Area Walk-By Checklist (AWC)Location: Bldg. CONTROL Floor El. 112 Room, Area¹: TD-T13**Instructions for Completing Checklist**

This checklist may be used to document the results of the Area Walk-By near one or more SWEL items. The space below each of the following questions may be used to record the results of judgments and findings. Additional space is provided at the end of this checklist for documenting other comments.

Figure 1 – Spalling at HVAC Support (TC-T12 Control 112)

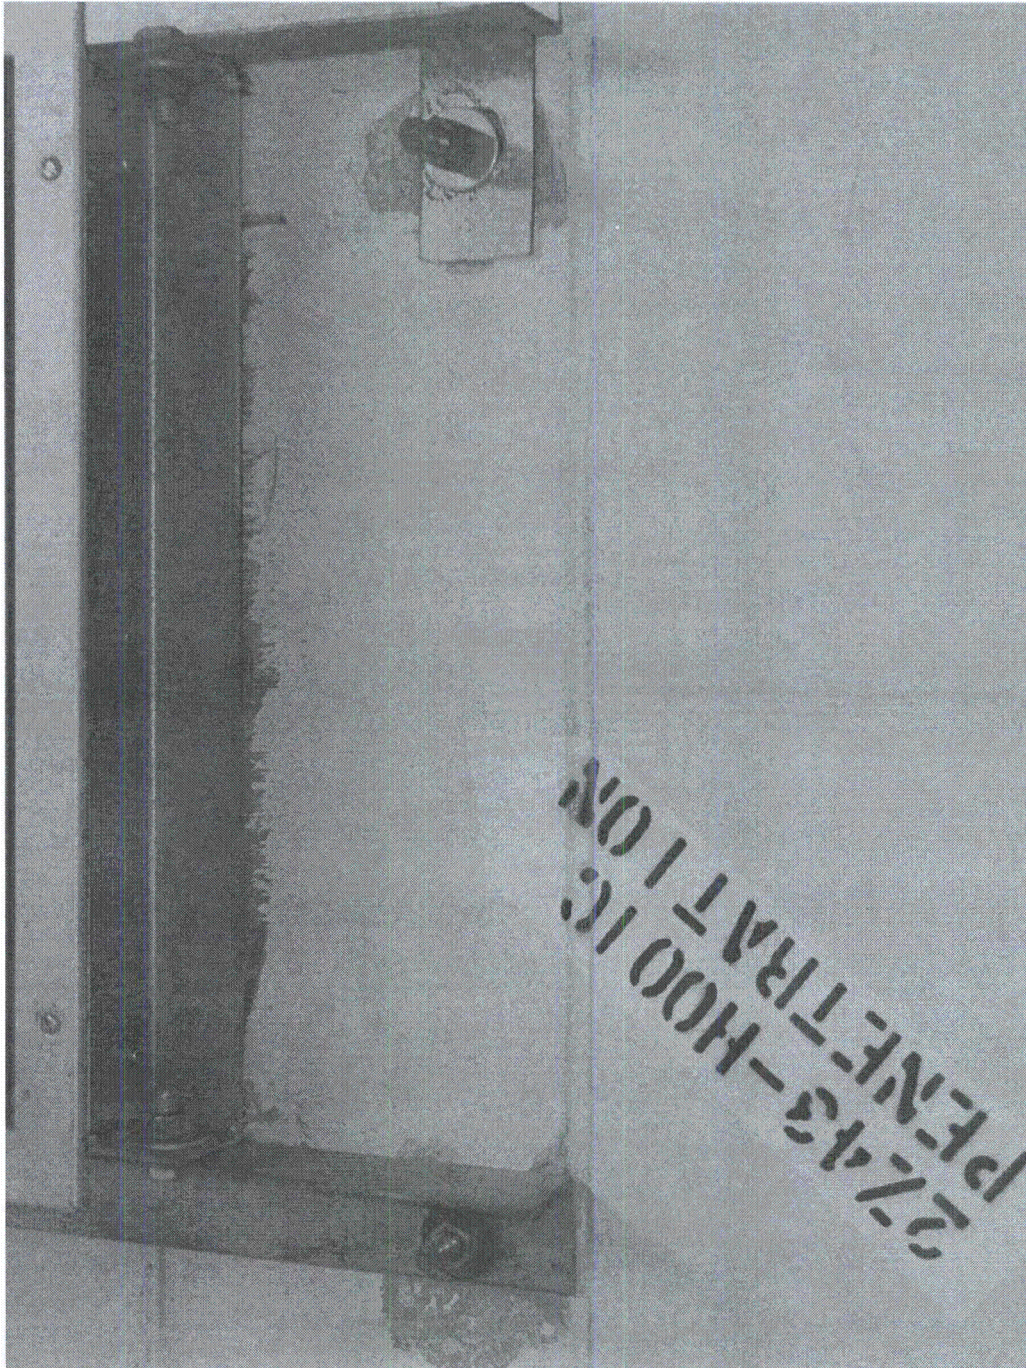
The HVAC damper at penetration 2Z43-H001C has block spalling at the two lower anchors. The duct is not safety related. Only one of the four anchor bolts has a double nut. The amount of spalling around the anchors is minor and the bolts are through-bolted. The spalling appears to have been caused by the drill during installation and not by the anchors. There is no spalling on the other side of the foot thick wall at the anchor support and there is no sensitive equipment beneath the HVAC damper. Therefore, the anchors are judged sufficient to restrain the damper and there is no potentially adverse seismic condition.

Figure 3 – Missing Cover Plate Screw (TC-T12 Control 112)

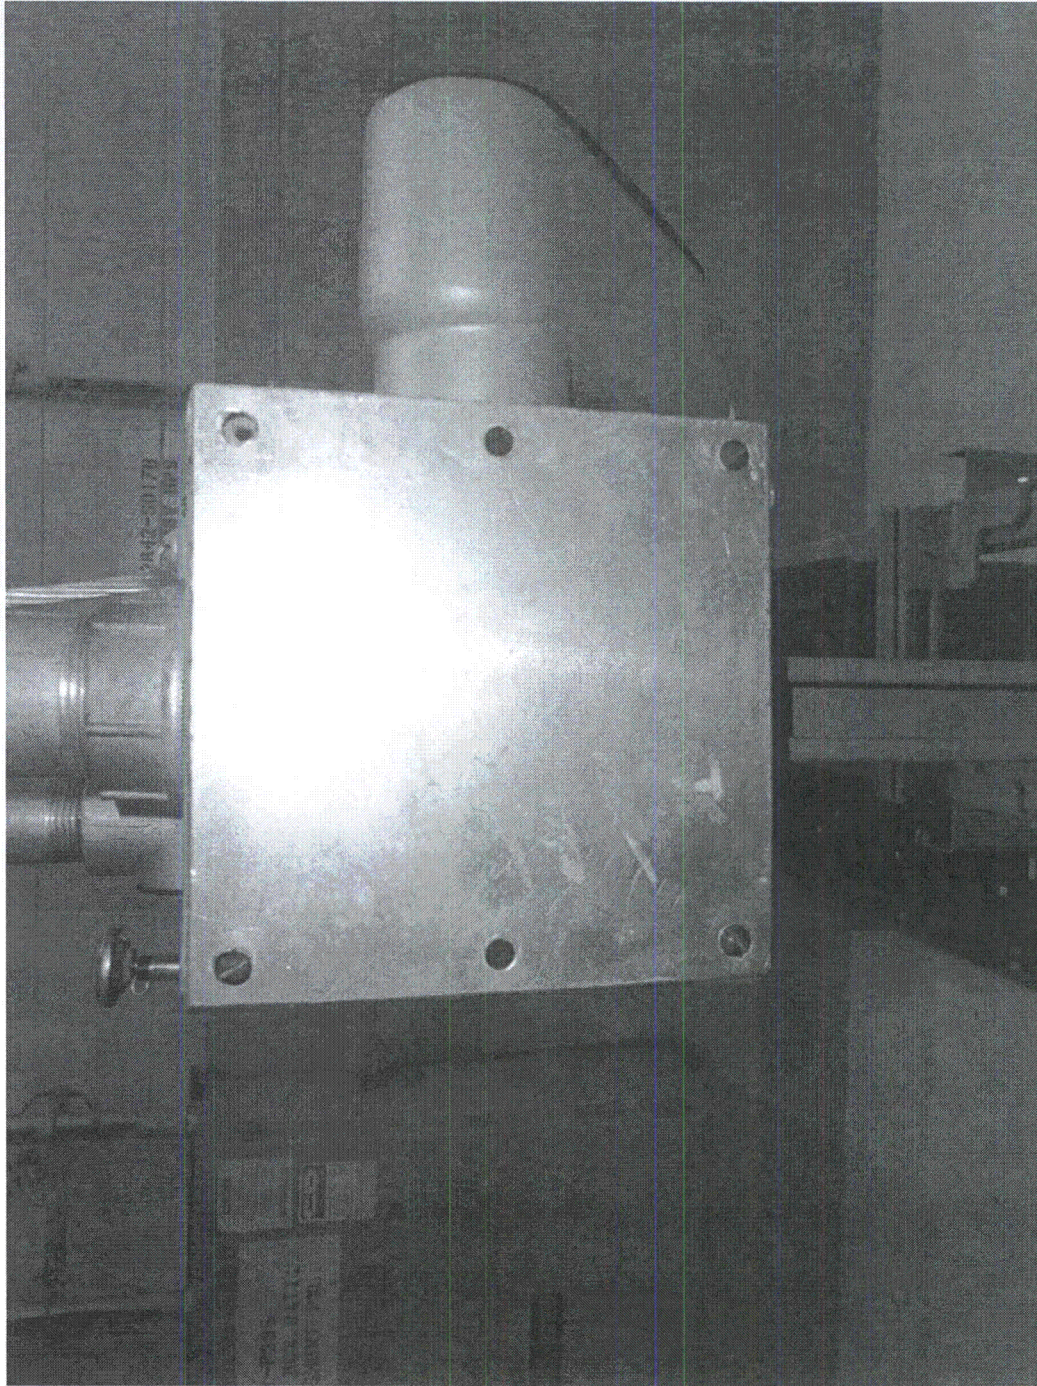
The junction box attached to battery rack 2R42-S017B is missing one screw in the top right corner of the cover plate (CR 519568). There are three existing screws and two holes in the cover plate that are not meant to have screws. The existing screws are judged to be sufficient to hold the cover plate in the case of a seismic event. Therefore, it is judged that there is no potentially adverse seismic condition.

Figure 1 – Replacement Welds (Room C-114)

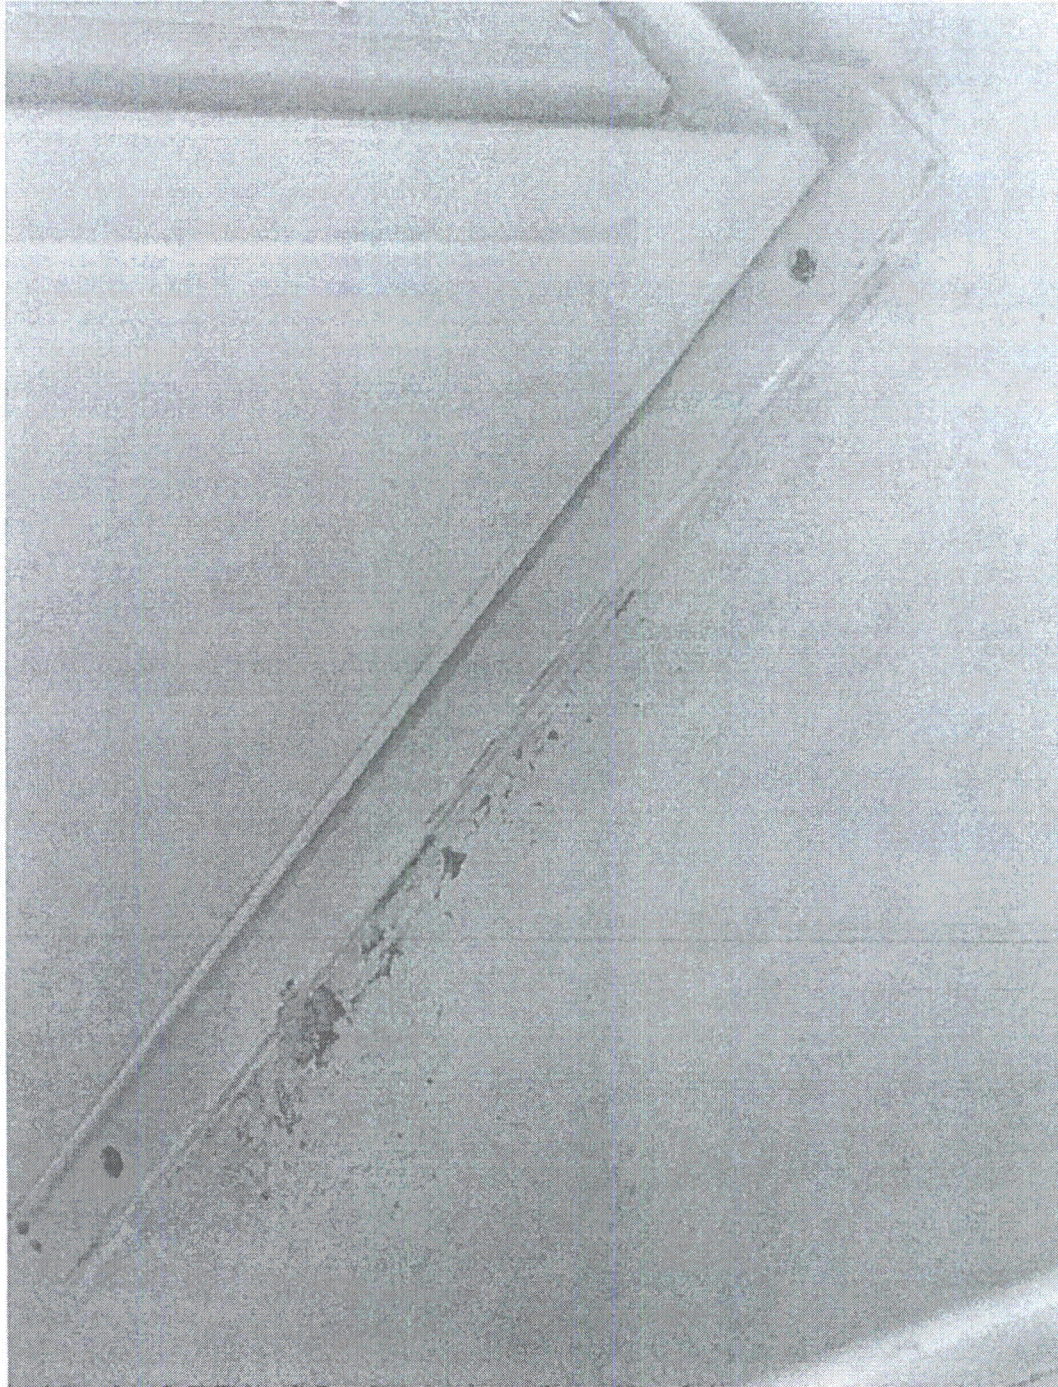
1. Does anchorage of equipment in the area appear to be free of potentially adverse seismic conditions (if visible without necessarily opening cabinets)? Y N U N/A
There are two anchor bolt holes without anchor bolts on 2R42-S028. However, review of SEWS package 2R42-S029 and adjacent battery chargers show that the anchors were replaced with welds, so there are no missing anchors. The existing welds have been verified against the SEWS packages and found to be in compliance. Therefore, there is no potentially adverse seismic condition.

Figure 4 – Missing Screw and Washer (Room C-114)

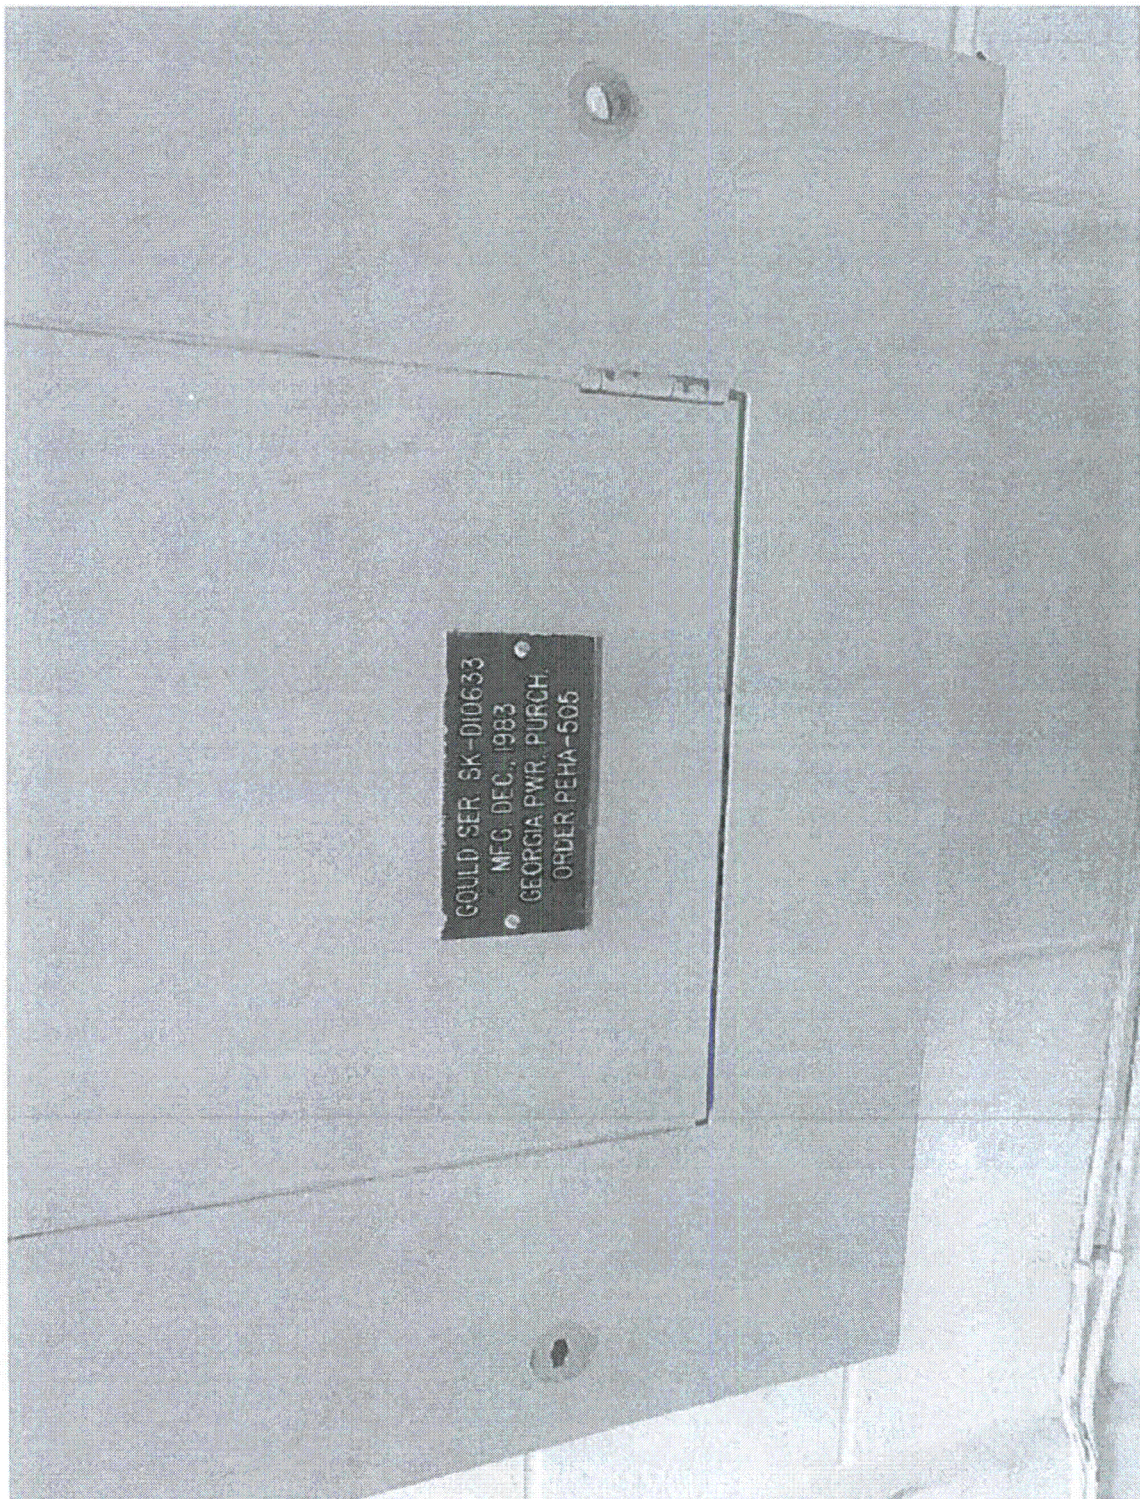
8. Have you looked for and found no other seismic conditions that could adversely affect the safety functions of the equipment in the area? Y N U
There is one screw missing and one screw missing a washer on the Q2R25-S129 distribution panel (CR 524321). The remaining four screws are sufficient to hold the light gauge cover plate, so there is no potentially adverse seismic condition and operability is not affected. However, the missing screw and washers should be replaced.

Figure 2 – Light Fixture over Cabinet (C140)

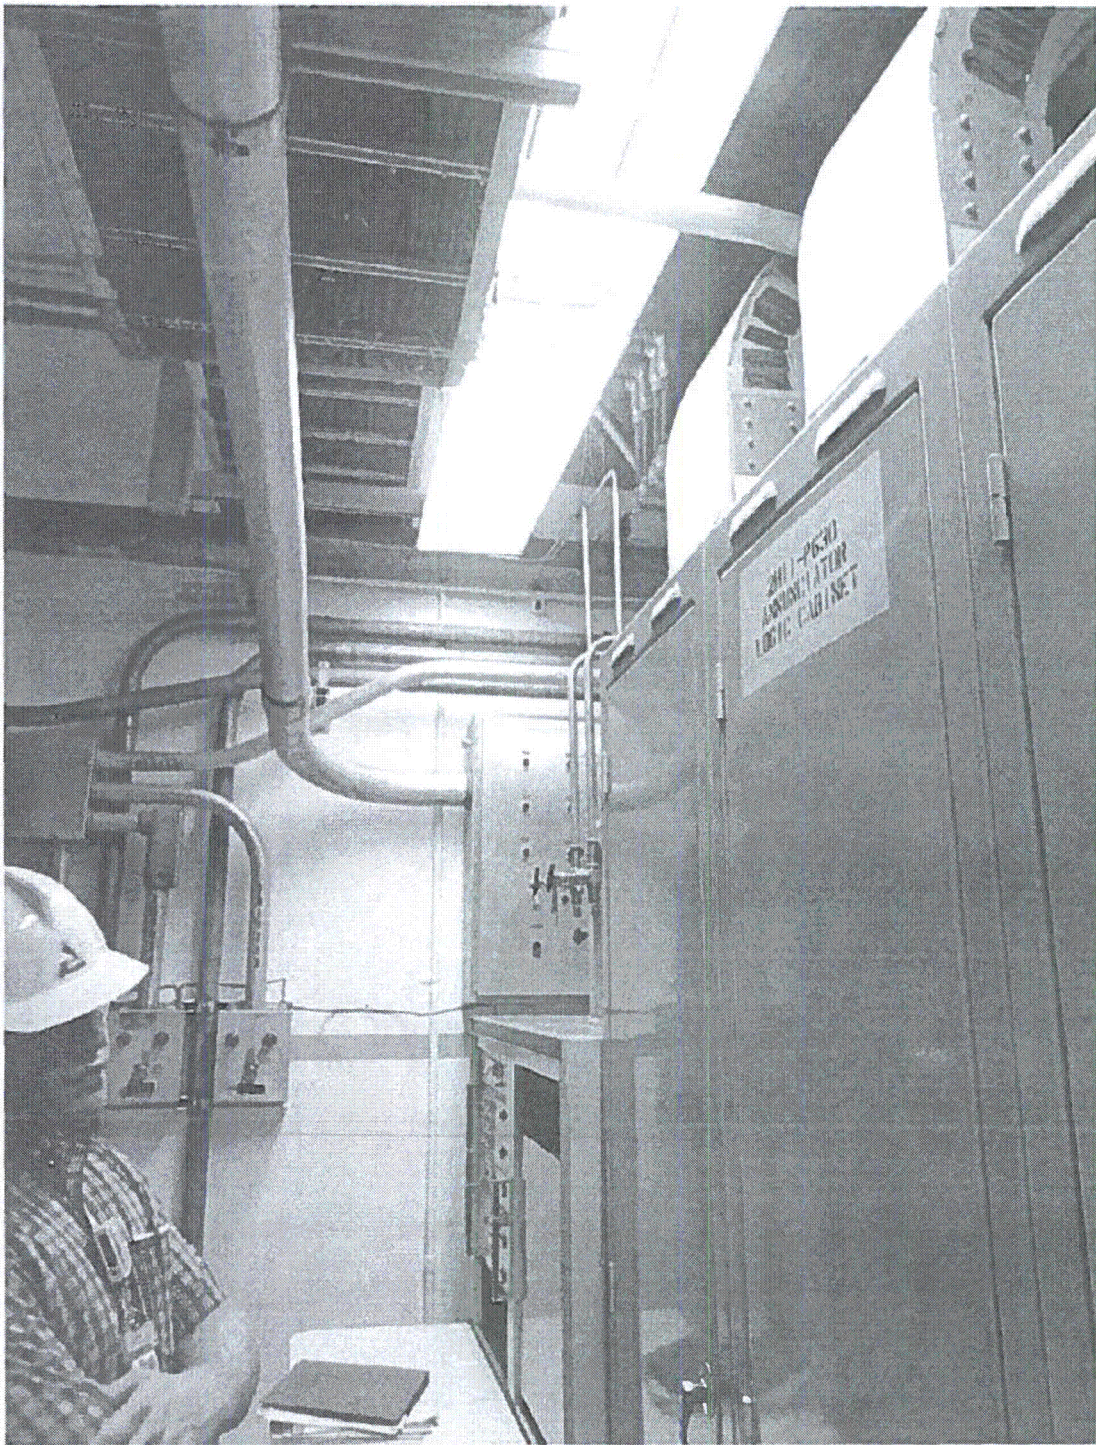
There is a fluorescent light fixture without a cover located approximately 5' above a cabinet. The light is tied to the ceiling, so during a seismic event, only the bulb could fall. The cabinet is rugged and is judged to have sufficient strength as to make a possible impact between the cabinet and the bulb insignificant. Therefore, it is judged to be seismically adequate.

Figure 1 Equipment Tag on Floor at 130' Elevation of the Reactor Building

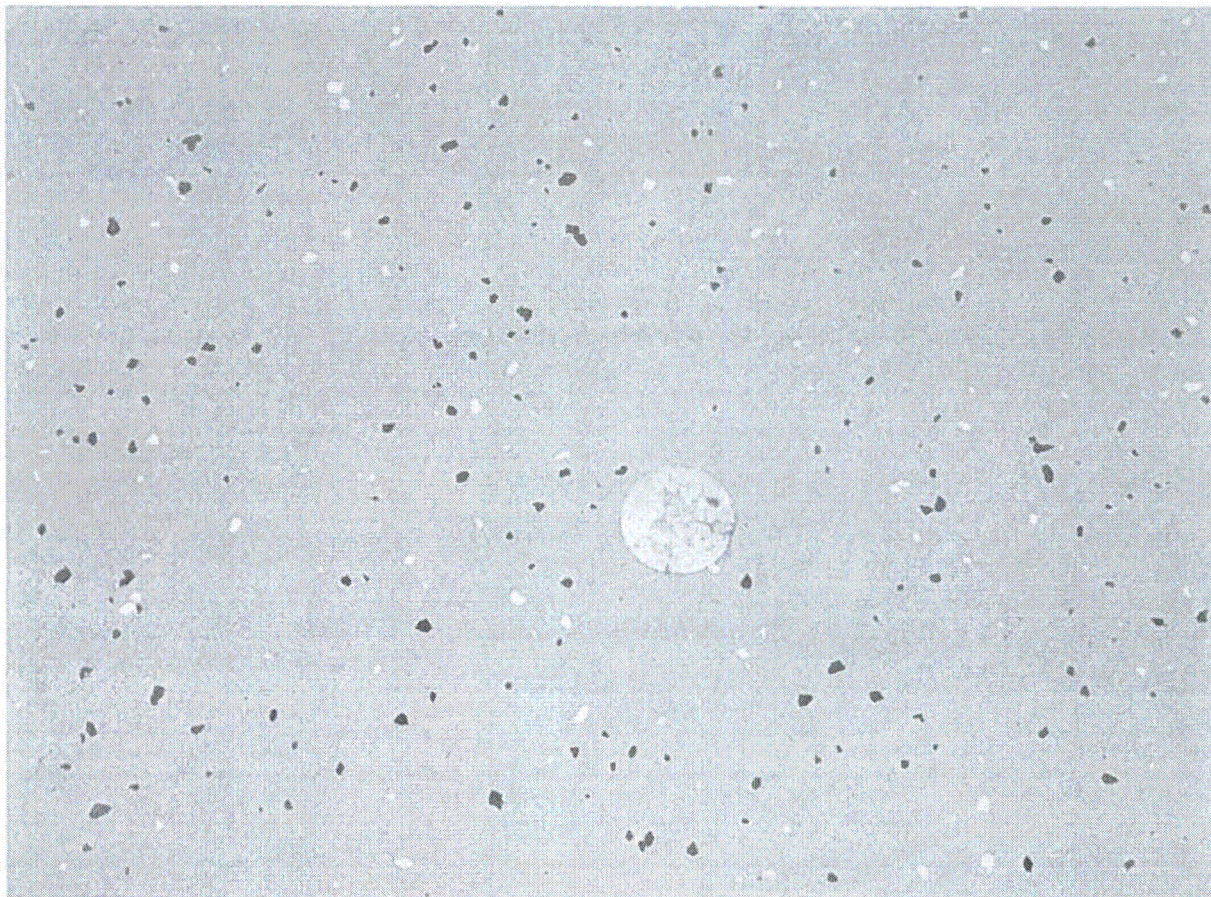
There is an Equipment Tag laying on the 130' elevation floor near 2H21-P410. The SWE's have determined that the tag is small and will not cause an adverse seismic interaction with safety related equipment (See CR 518762).

Figure 1: Drilled Clip Angle Welded to Web of Small Wide Flange

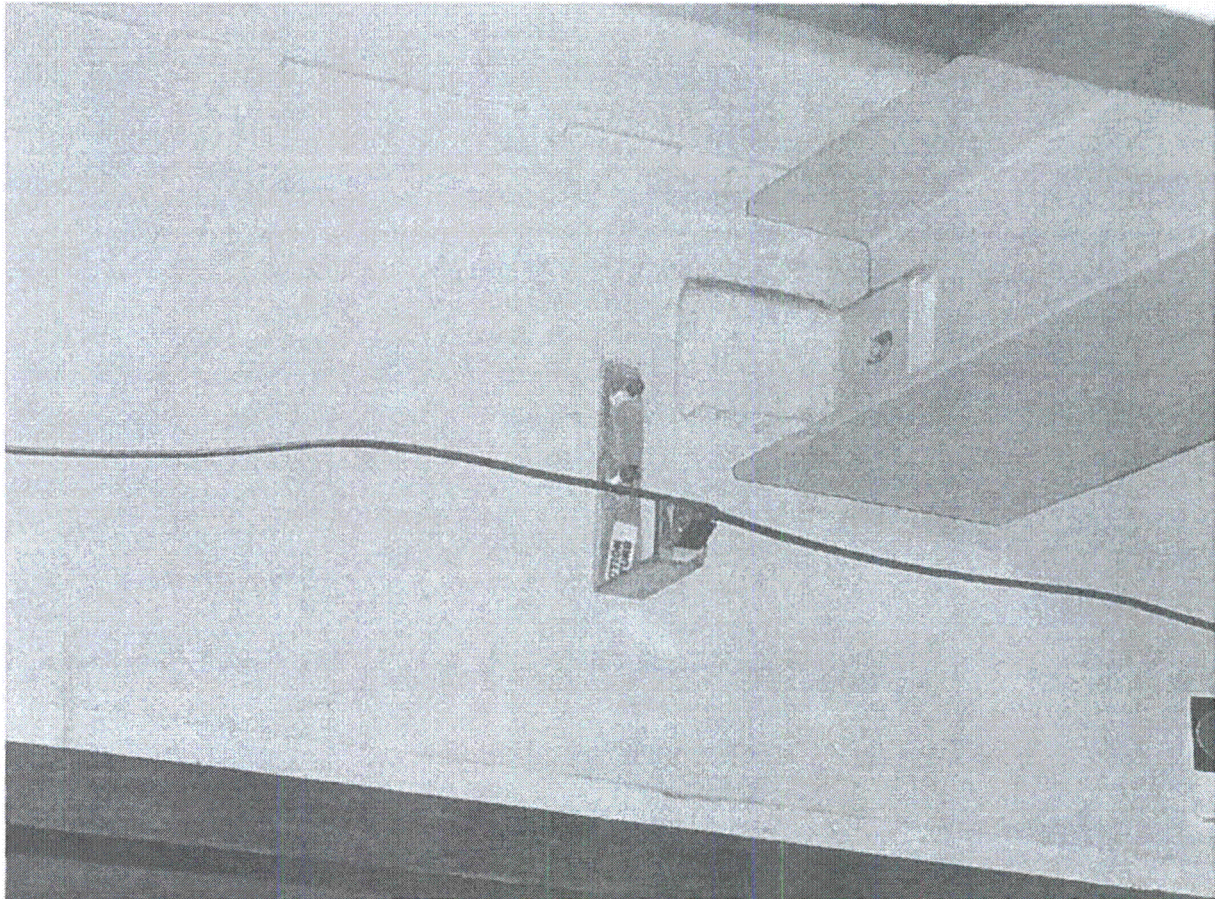
Clip angle in upper platform steel with drill hole then welded to web of wide flange. This appears to be a change in structural steel methodology. The weld is on three sides of the clip angle and the SWE's have determine the weld has sufficient seismic capacity compared to the original design .
